UNITED STATES PATENT AND TRADEMARK OFFICE

| APPLICATION NO. | FILING DATE | FIRST NAMED INVENTOR | ATTORNEY DOCKET NO. | CONFIRMATION NO. |
|-----------------|-------------|----------------------|---------------------|------------------|
| 09/751,422 | 12/29/2000 | James Allen Cox | 1100.1130101 | 7848 |

Office Action Summary

DETAILED ACTION***Response to Amendment***

FIG. 10

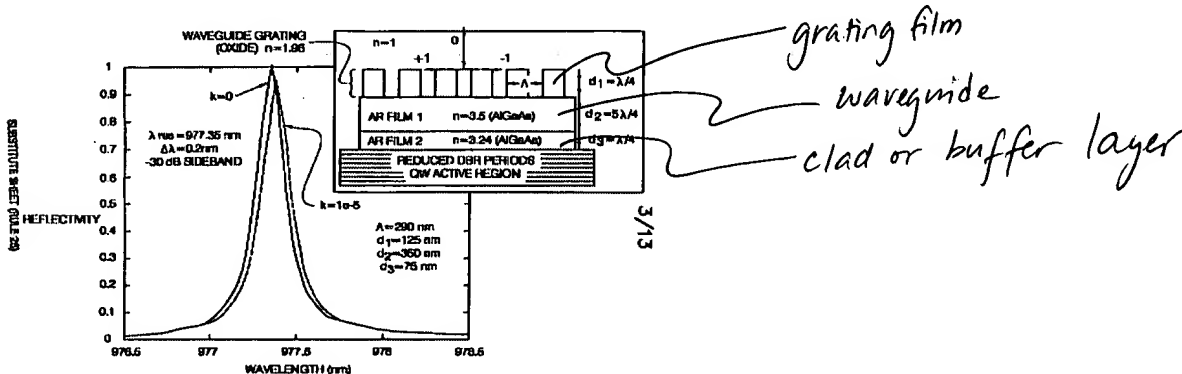
4. Claims 14-17 are rejected under 35 U.S.C. 102(b) as being anticipated by Alferness et al (4,904,045). Alferness et al discloses the claimed invention. Note the

waveguide (118) and the grating film (114).

**Fig.3**

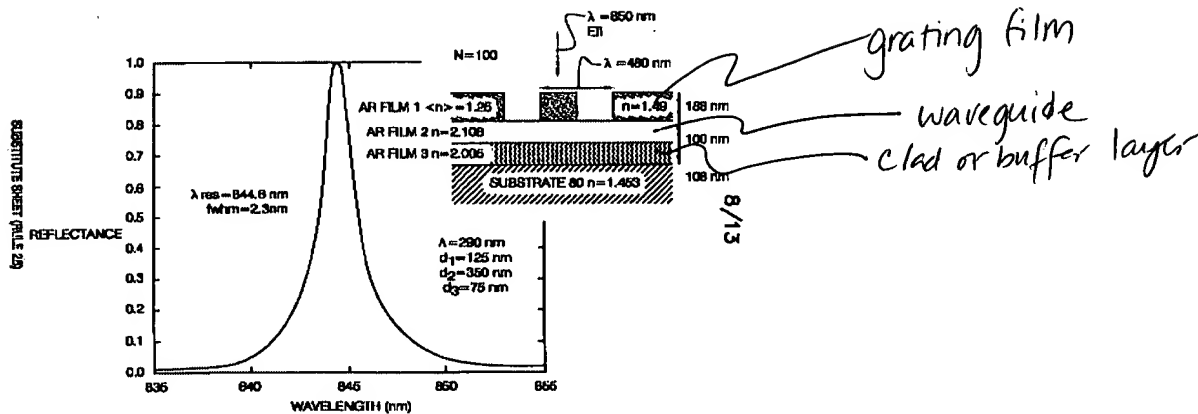
3. Claims 1-13 and 18-21 are rejected under 35 U.S.C. 102(b) as being anticipated by Cox et al (WO 98/57402). Cox et al discloses the claimed invention. Note figures 3 and 7 which illustrate in particular the cladding or buffer layer having a sufficiently low

refractive index relative to the refractive index of the waveguide. Further note page 6-7 which disclose that the figures 3 and 7 are to be used in the optoelectronic device of figures 5 and 6, respectively.

FIG. 5b

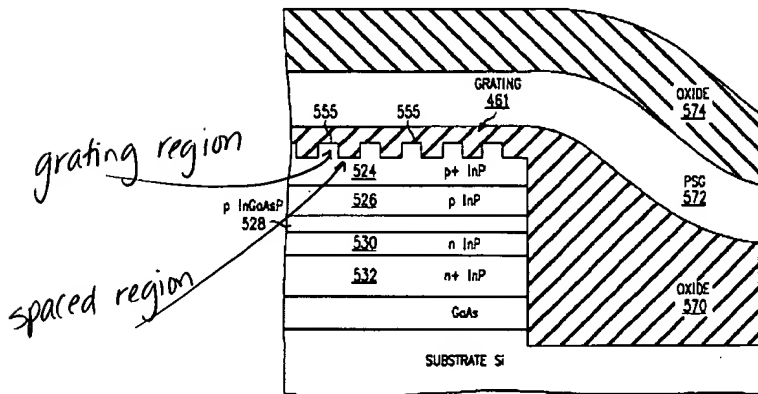
5. Claims 14-17 are rejected under 35 U.S.C. 102(b) as being anticipated by Congdon et al (5,673,284). Congdon et al discloses the claimed invention. Note for example figure 5b which illustrates the waveguide (572) and the grating film (524).
